N6700B-04A

# Information Only Service Note

## N6700B - Low-Profile Modular Power System

Different Color Front Panel LCD Display

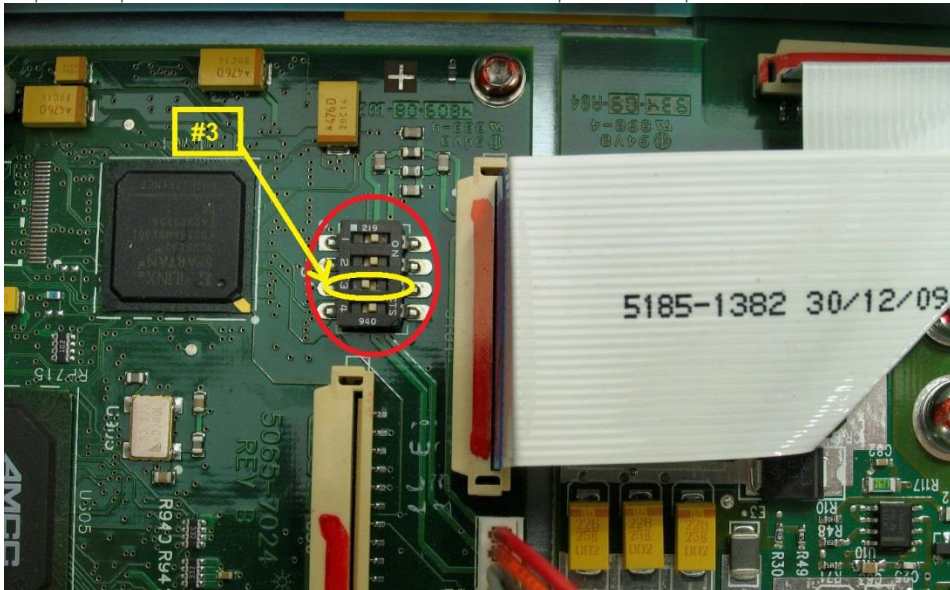
Blue/white Front Panel LCD Display (below) has been obsoleted.

LCD (blue/white display assembly, part no. 2090-1031) has been discontinued by vendor. Replacement assembly (pictured later) is part no. 5067-5993 (amber in color). Difference in color doesn't impact any performance and specification. Unfortunately, this cannot be altered.

- 1) New LCD display (5067-5993) is a mechanical & functional “drop-in” replacement for the original.

- 2) 4-pole dip switch on PPMC PCA must have pole #3 repositioned to “off” as shown below:

- 3) Instrument firmware must be version D.04.01 or newer for proper operation of this display.
